L-2014-102
10 CFR 52.3

Re: Florida Power & Light Company
Proposed Turkey Point Units 6 and 7
Docket Nos. 52-040 and 52-041
Supplemental Response to NRC Request for Additional Information Letter No. 72
(eRAI 6985) SRP Section 11.02 - Liquid Waste Management Systems

SRP Section: 11.02 – Liquid Waste Management System

NRC RAI Number: 11.02-6-5 (eRAI 6985)

Figure 1 – Deep Injection Well (typical based on DIW-1EW-4)

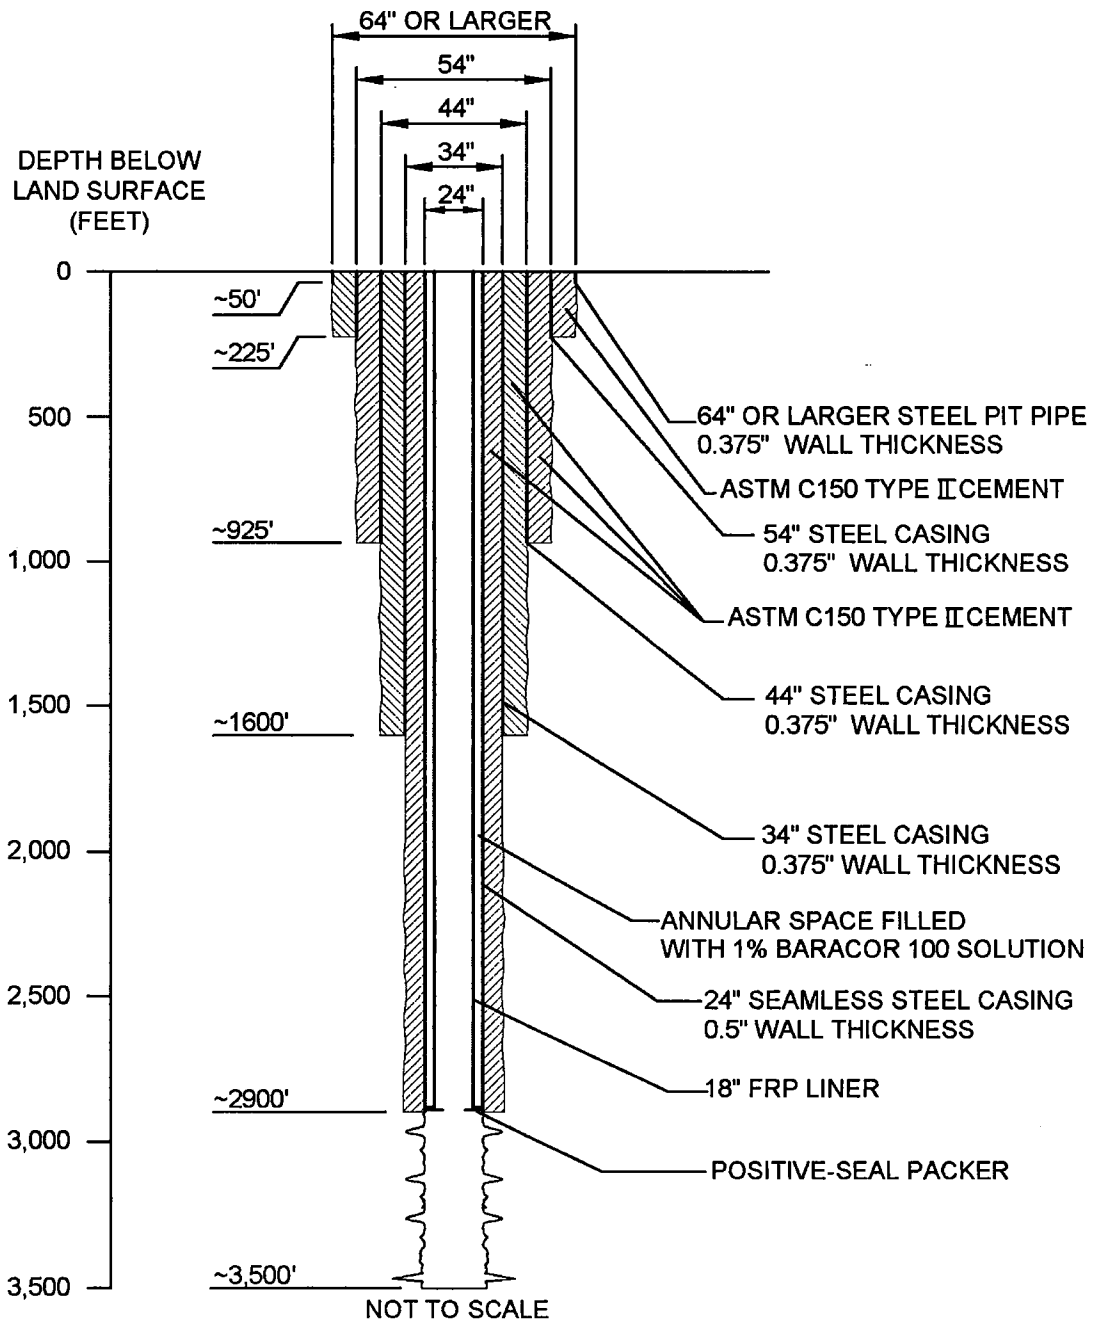
Since the deep well injection system will involve the use of 12 injection wells in relatively close proximity, the applicant is requested to address (1) a rise in pressure given the combined operation of multiple wells, and (2) potential fractures and formation of hydraulic connections, followed by upwelling into the above confining units. Regarding possible failures of well casings, the applicant is requested to describe design features of well casings and joints, and measures that will be implemented in ensuring the mechanical integrity of the injection and monitoring wells over their operational lives. In this context, the applicant is requested to describe plant operations and procedures should any upwelling or failures of the injection system be noted, and whether interim provisions will be made to use backup systems in disposing or storing of radioactive liquid effluents. The applicant should also describe well abandonment procedures, if needed during the lifetime of the license, including steps to confirm the mechanical condition of the wells, and methods and materials that would be used to plug and seal wells.

Each of the deep injection wells will be constructed with concentric steel casings to isolate and protect groundwater from injected fluid. Each injection well will be constructed with new and unused 64- (or greater), 54-, 44-, 34-, and 24-inch outside diameter steel casings designed to last for at least 60 years. The 64- (or greater), 54-, 44-, and 34-inch diameter casings will have a minimum wall thickness of 0.375-inches and conform to American Society for Testing and Material (ASTM) 139, Grade B specifications. The final 24-inch diameter casing will have a 0.5-inch wall thickness, will be seamless, and will conform to American Petroleum Institute (API) 5L specifications or ASTM 153 specifications. The well casings are selected to provide protection against casing failure during cementing operations, protect against failure during operation of the well and subsequent pressure tests, and provide sufficient corrosion protection. The 54-, 44-, and 34-inch diameter casings will be encased in cement on both the outside and the inside of the casing to protect against exposure to groundwater. The outside of the 24-inch diameter casing will be encased in cement to protect against exposure to groundwater. A nominal 18-inch diameter fiberglass reinforced plastic (FRP) injection tubing

with a wall thickness of 0.76-inches will be installed inside the 24-inch diameter casing to protect the 24-inch diameter casing from exposure to injected fluids and subsequent corrosion. The annular space between the 24-inch diameter casing and the FRP injection tubing will be filled with a non-hazardous corrosion inhibitor (e.g. one percent Baracor 100 solution) and sealed at the base and top to create a pressure-tight annular space. Thus, each steel casing is either fully encased in cement or, for the 24-inch diameter casing, the outside of the casing is encased in cement while the inside of the casing is protected by a corrosion inhibitor. Figure 1 depicts a typical deep injection well. This schematic is based on the actual subsurface conditions encountered during the installation of deep injection well DIW-1 ~~exploratory well EW-4~~.

The FRP injection tubing will be installed by screwing together threaded FRP injection tubing joints of approximately 30-foot lengths. A non-hazardous compound (TFC-15 thread compound) will be applied to the threads of each FRP pipe joint to assist in the screwing together of the joints and to assist in completing a pressure-tight connection. The FRP injection tubing will be installed to a depth of approximately 10-feet above the base of the 24-inch diameter casing, where it will be seated into a packer to allow a pressure tight seal between the FRP injection tubing and the 24-inch diameter casing. Just prior to seating the FRP injection tubing into the 24-inch diameter casing, the water in annular space between the FRP injection tubing and the 24-inch diameter casing will be displaced with a non-hazardous corrosion inhibitor by pumping the corrosion inhibitor into the annular space from surface. Following completion of seating the FRP injection tubing into the packer near the base of the 24-inch diameter casing, the annular space between the FRP injection tubing and the 24-inch diameter casing will be sealed at surface.
